Subject of this Document: (Title) "Power-Cooling-Mismatch Test Series, Test PCM-7 EOS"

DOCUMENT REVISION REQUEST

② REQUESTER: D. T. Sparks
 ③ DRR DATE: 4/15/80
 ④ DRR NO: TFBP-241
 ⑤ DOCUMENT NO. (IF APPLICABLE): TFBP-TR-311
 DOCUMENT TITLE: Power-Cooling-Mismatch Test Series, Test PCM-7 EOS
 DOCUMENT ISSUE DATE: February 1979
 ⑥ CHECK APPLICABLE, BLANK: PERMANENT CHANGE TEMPORARY CHANGE _____ BULLETIN _____
 ⑦ MANAGER APPROVAL: _____ DATE: _____

Fig. 1 Schematic of Test PCM-7 nine-rod cluster, showing the locations of the fuel rod instrumentation with respect to the bottom of the fuel stack.

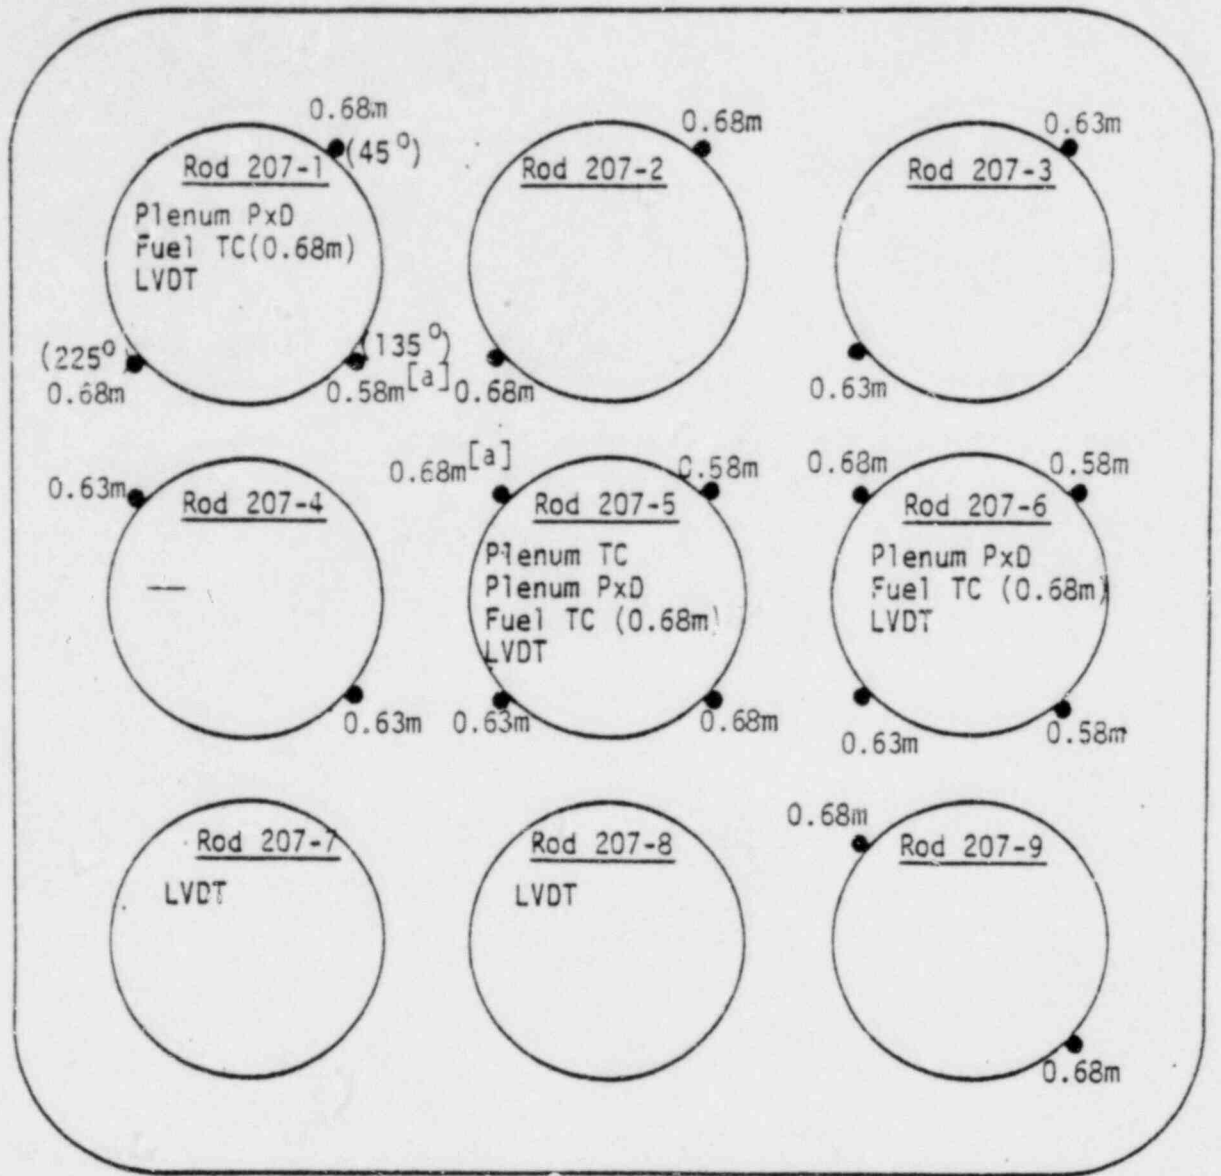
ITEM	PAGE	STEP OR PARA.	INSTRUCTIONS. REWRITE PARAGRAPH(S) OR FOR EXTENSIVE CHANGES ATTACH REVISED COPY AND STATE "REVISE PER ATTACHED COPY" FOR NEW DOCUMENT. ATTACH ROUGH DRAFT AND STATE "PREPARE NEW (SP, DOP, ETC.) PER ATTACHED DRAFT"
1	5	Fig. 1	Replace Figure 1 with attached figure.
2	6	1	Replace Item (1) with attached.
3	14	Table III	Delete one 0.58 m cladding T/C on Rod 207-1, and hot and cold leg spool piece RTDs.
4	17	Table IV	Under Instrument for fuel rod 207-1, "Cladding T/Cs (4)" should read "Cladding T/Cs (3)". Delete hot and cold leg spool piece RTDs.
5	26	Lines 4 & 5	"Approximately 30 seconds." should read "2 to 5 minutes."
6	26	Line 6	"30 seconds" should read "2 to 5 minutes."
7	26	Para. 1	Replace paragraph 1 "following the two ... failure propagation." with attached paragraph.
8	26	Para. 2	Replace paragraph 2 "following film ... nuclear operation." with attached paragraph.

(*) Rods 207-5 and 207-6 will each have four cladding surface thermocouples located circumferentially and axially as shown in Figure 1. Rod 207-1 will have three thermocouples located as shown on Figure 1. Rods 207-2, 207-3, 207-4 and 207-9 will each have two thermocouples located as shown on Figure 1. Sixteen of the cladding thermocouples are 1.17 mm outside diameter (spaded junction), titanium sheathed, platinum-rhodium (Type S) thermocouples. The other three will be small diameter (0.71 mm OD) thermocouples, one on Rod 207-1 and two on Rod 207-5. These cladding thermocouples are zircaloy sheathed, BeO insulated, W5%Re/W26%Re wires.

⑩ JUSTIFICATION: (REASON FOR CHANGE — NUMBER TO CORRESPOND TO ITEM NO. ABOVE):
 1,2,3,4,12,13,16,17,18,19,20 - As fabricated instrument changes.
 5,6,7,8 - Allow more comprehensive evaluation of test results relative to experiment objectives.
